TO: Rob Young, PE Project Manager Vermont Agency of Transportation	DATE	PROJECT NO.
	12/2/2015	Woodstock BRF 0151 (21)

COPIES	NUMBER	DESCRIPTION	CODE
1		Bridge Rail Sheets 1 - 4	H
1		Bridge Rail WPS 3008 & 3009	H
1		Rail Transitions Sheets 1 - 5	H
1		Rail WPS 3007, 3009, 3016, & 3022	H

BRIDGE RAIL DETAILS SHEET
 VERMONT ROUTE 106 (MAJOR COLLECTOR, RURAL), BRIDGE # 24
 TOWN OF WOODSTOCK, COUNTY OF WINDSOR, VT.

SHEET 1 OF 4

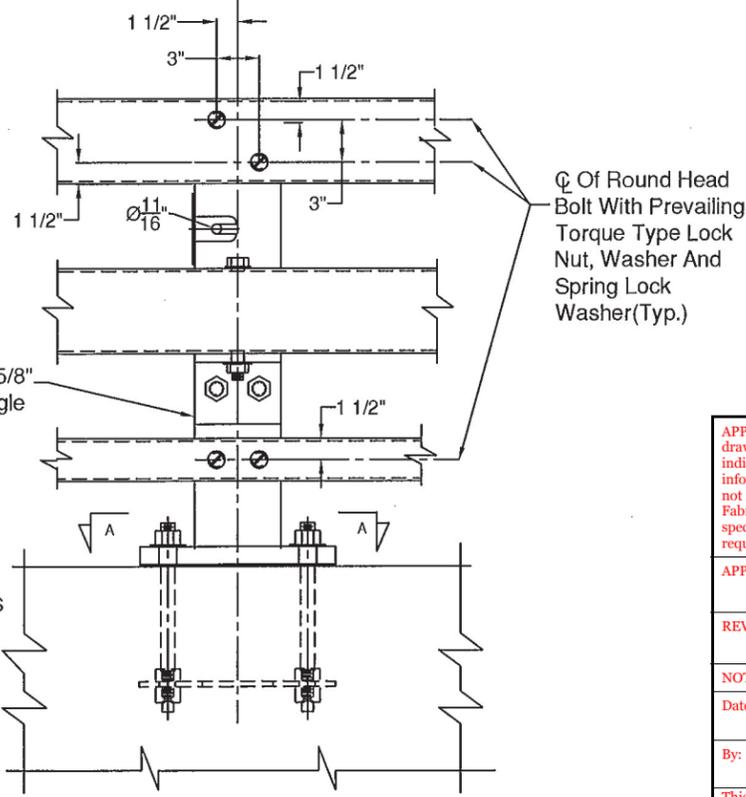
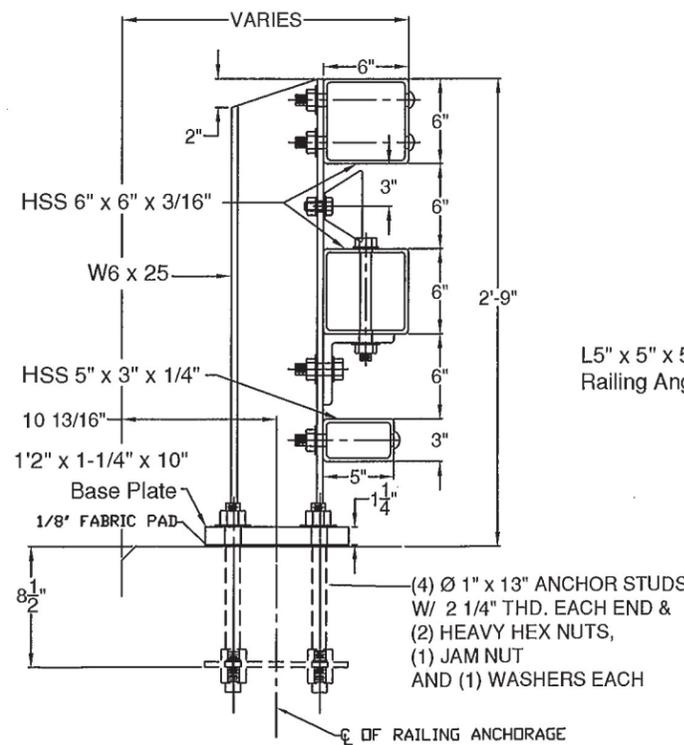
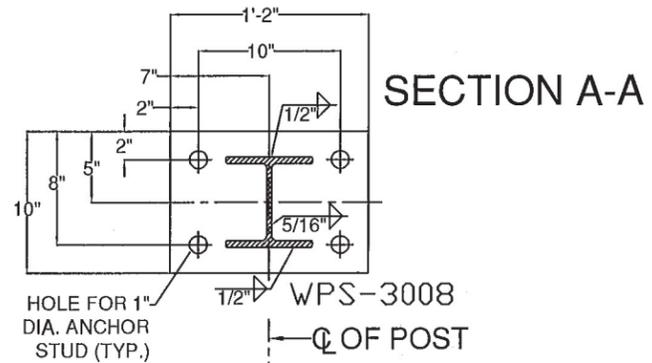
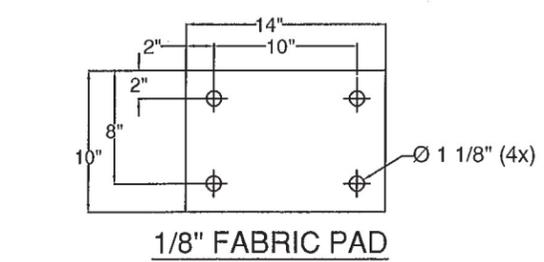
Weld procedures require re-submittal. Please resubmit the entire package to reflect any changes required for the welding procedures.

BRIDGE RAIL DETAILS SHEET
VERMONT ROUTE 108 (MAJOR COLLECTOR, RURAL), BRIDGE # 24
TOWN OF WOODSTOCK, COUNTY OF WINDSOR, VT.

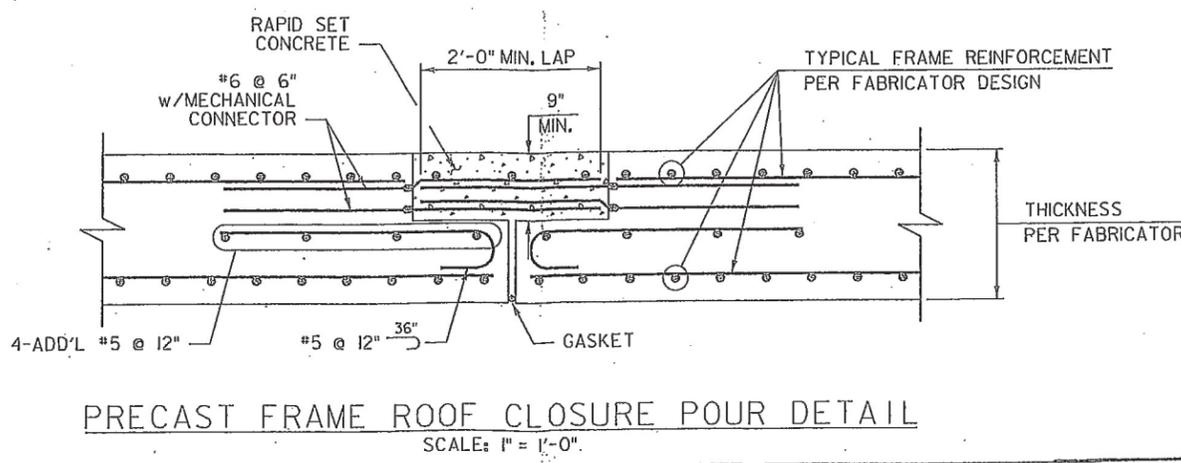
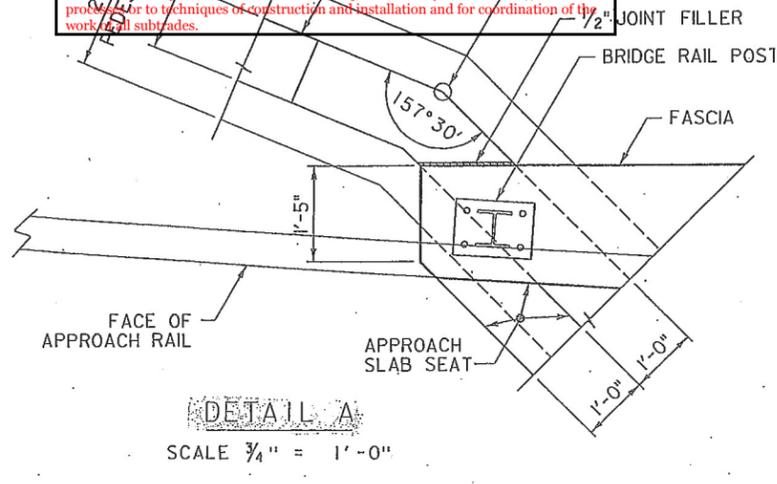
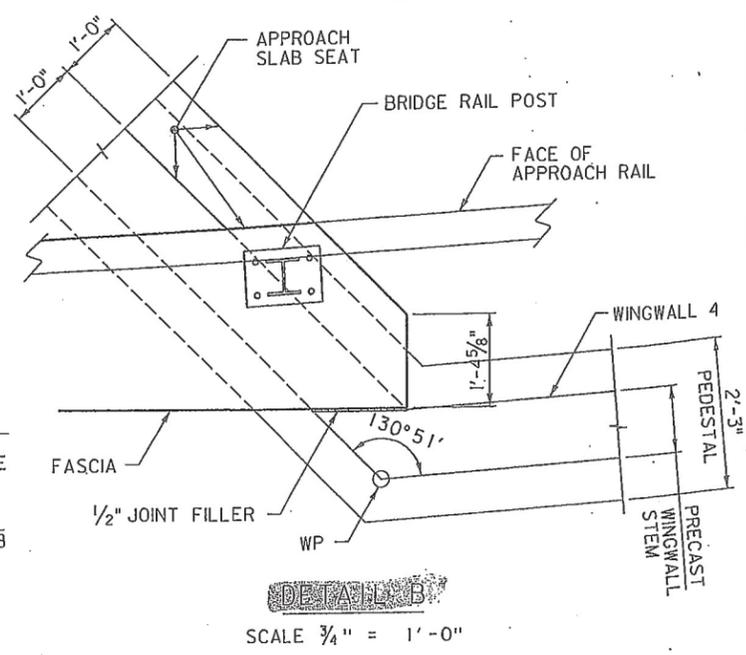
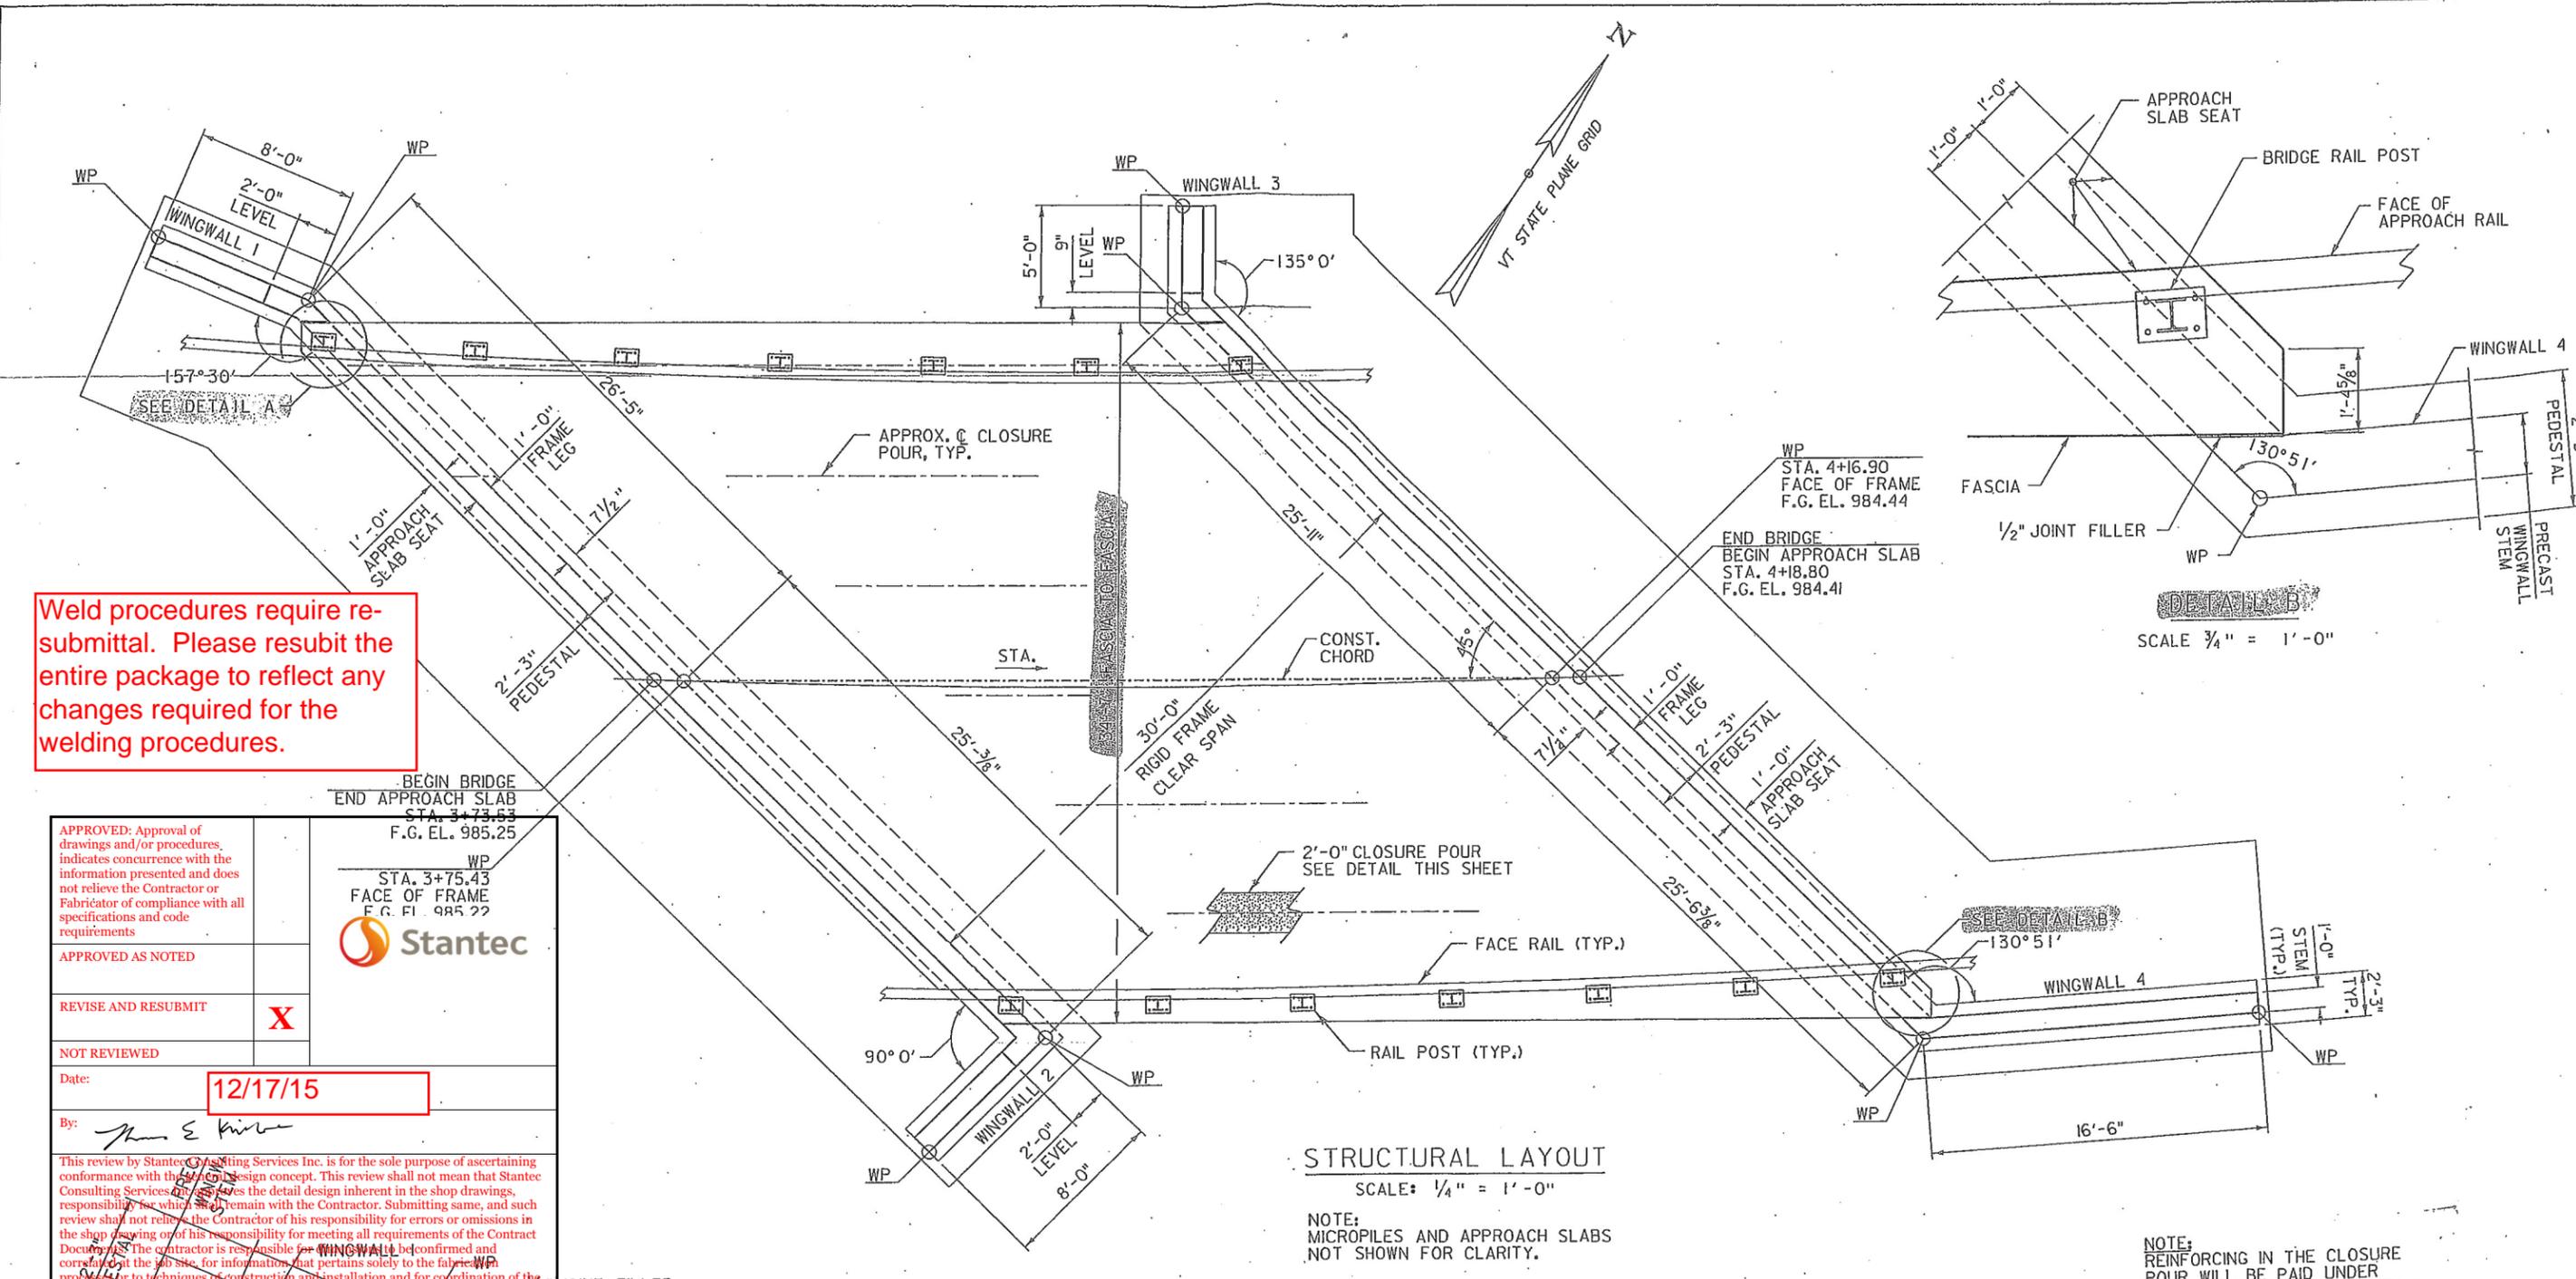
Weld procedures require re-submittal. Please resubmit the entire package to reflect any changes required for the welding procedures.

SHEET 3 OF 4

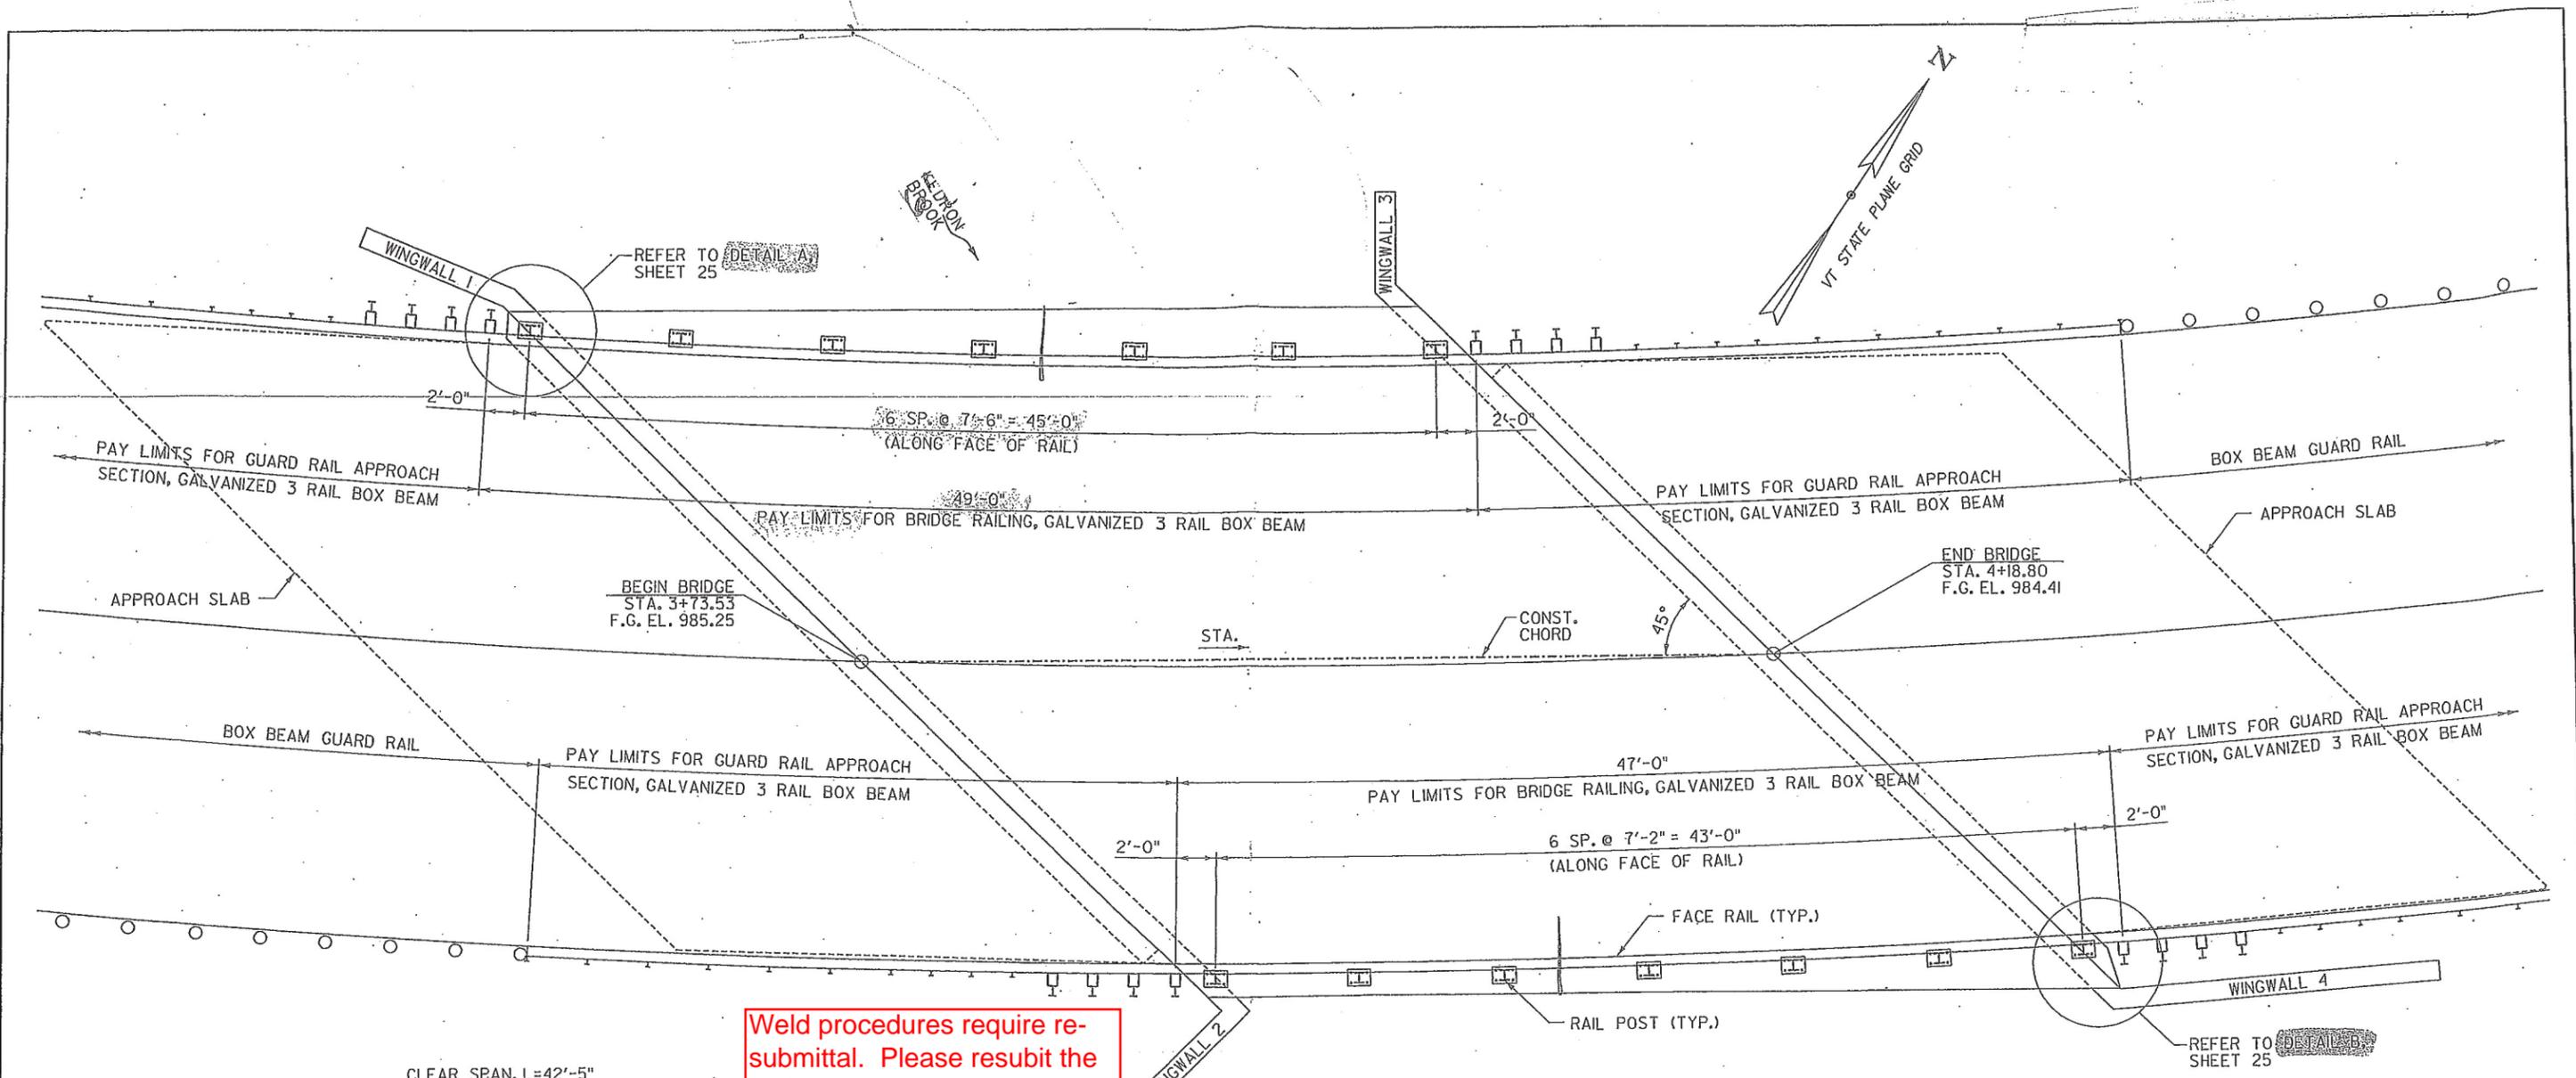
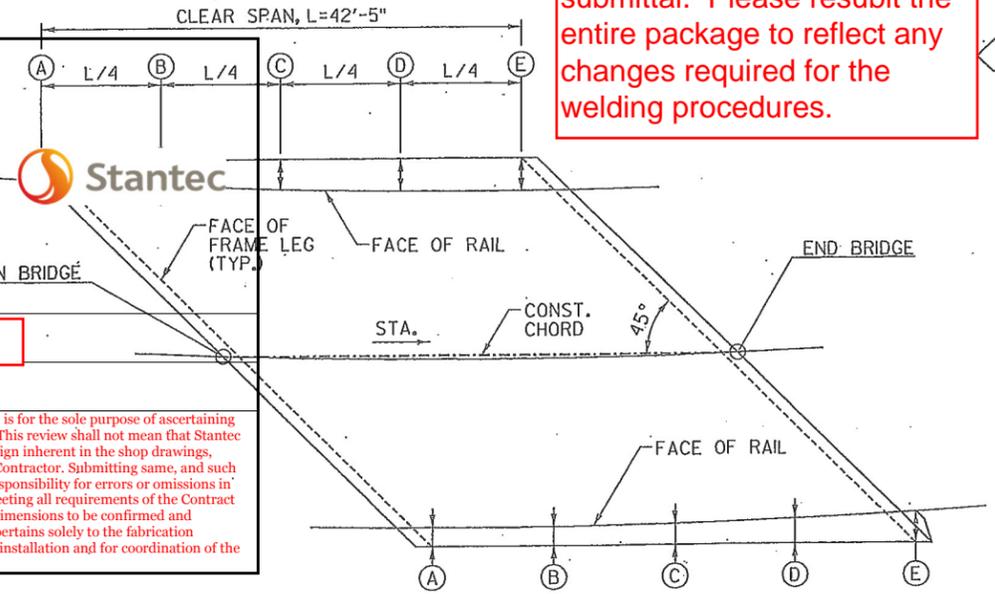
Weld procedures require re-submittal. Please resubmit the entire package to reflect any changes required for the welding procedures.

SHEET 1 of 5

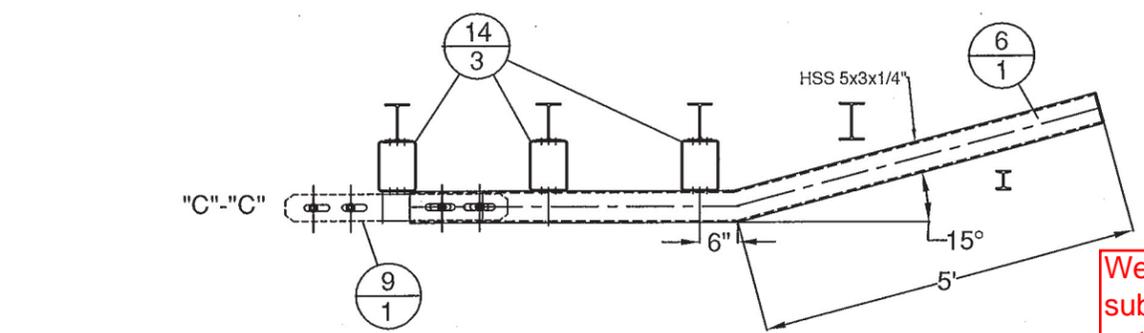
Weld procedures require re-submittal. Please resubmit the entire package to reflect any changes required for the welding procedures.
